Portland General Electric Company

December 13, 1979

Enclosed are responses to the five questions posed at the exit meeting on December 6, 1979 in Bethesda, Maryland regarding LER 79-15 and supplements thereto.

BLOCK-CORE INTERFACE NORMAL STRESS DISTRIBUTION

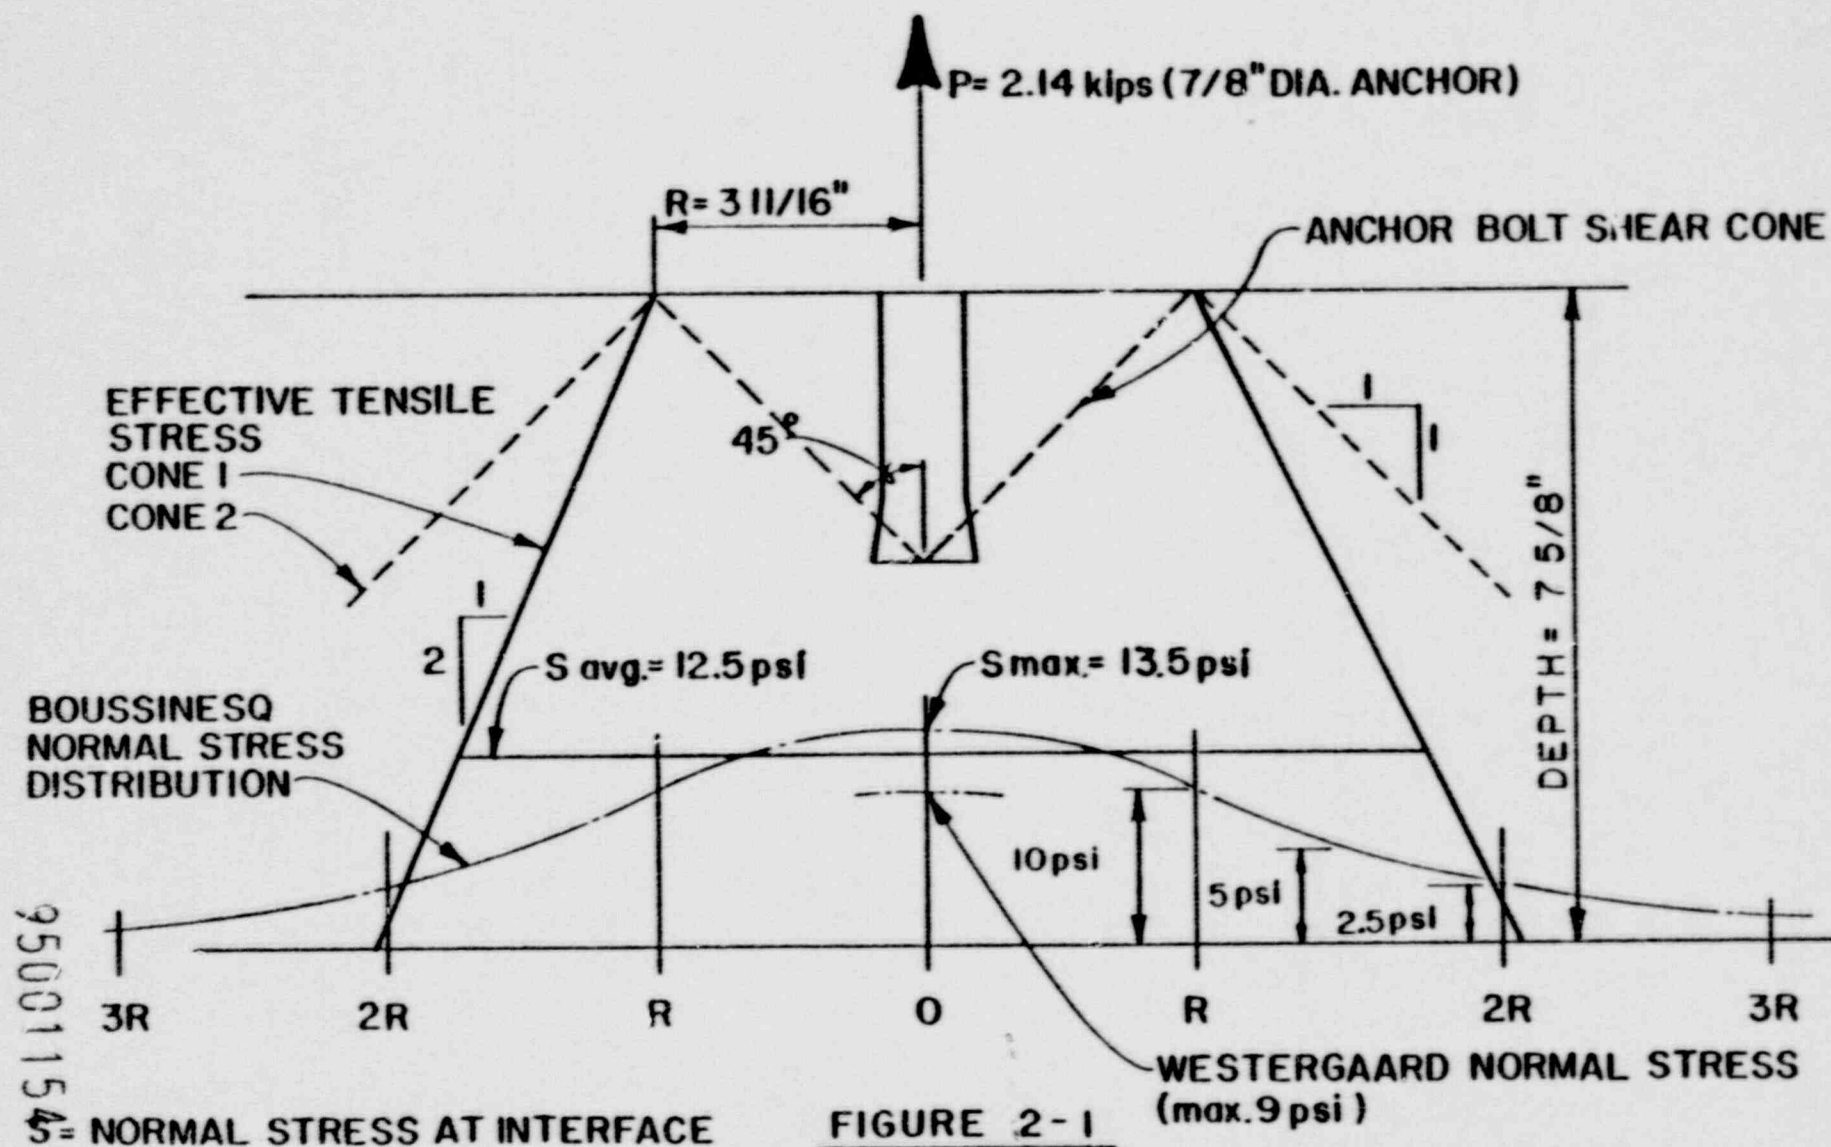
Provide the basis for the stress distribution considered at the interface between the masonry block and concrete core due to pipe restraint anchor bolt loads.

The resistance to tension developed in an expansion anchor bolt occurs in the flared section at the end of the anchor bolt. If a tensile force is placed on the bolt, shear and compression stresses develop in the zone adjacent to and above the flared portion. The load is thereby distributed horizontally to the surface of the wall. The load spreading may be considered as a 45° shear cone which projects to the surface (see Figure 2-1). To estimate the tension at the interface between the masonry block and concrete core, the vertical component of the stress on the shear cone is assumed to be uniformly distributed over the circular area formed by the intersection of the cone and the block surface. The tension on the masonry block-concrete core interface due to the surface stresses can be estimated using theories developed by Boussinesq for determination of stress distributions in an elastic media⁽¹⁾. The normal stress at the block-core interface as derived from this theory is shown on Figure 2-1. The maximum stress was calculated from the Boussinesq equation for a circular area with a uniform load, and the stress distribution was obtained from stress curves⁽²⁾. Also shown is an average normal stress for a cone with 2:1 slope (Cone 1). It can be seen that this cone gives a good approximation of the stress calculated from the Boussinesq equation at the interface.

The tension on the masonry block-concrete core interface due to the surface stresses can also be calculated using theories developed by Westergaard for calculation of soil stresses under circular foundations. The stress coefficients are shown in Table 2-1 along with a comparison

of the stress if cone 1 (2:1 slope) and cone 2 (1:1 slope) shown in Figure 2-1 are used. This table gives the ratio of the maximum stress at depth Z with the applied uniform stress at the surface for the four methods indicated. For expansion anchor bolts ranging in size from 1/2 in. to 7/8 in. in diameter, the ratio $Z/2R$ ranges from 1.7 to 1.0 where R is the radius of the shear cone at the surface. For this range, cone 2 underestimates the stress and cone 1 provides an overestimate. For the upper range of $Z/2R$, the overestimate is by a factor of 2 to 3. Therefore, cone 1 is considered to provide a reasonable representation of the stress distribution and was used for calculating distribution for the tension stress at the concrete core-block interface.
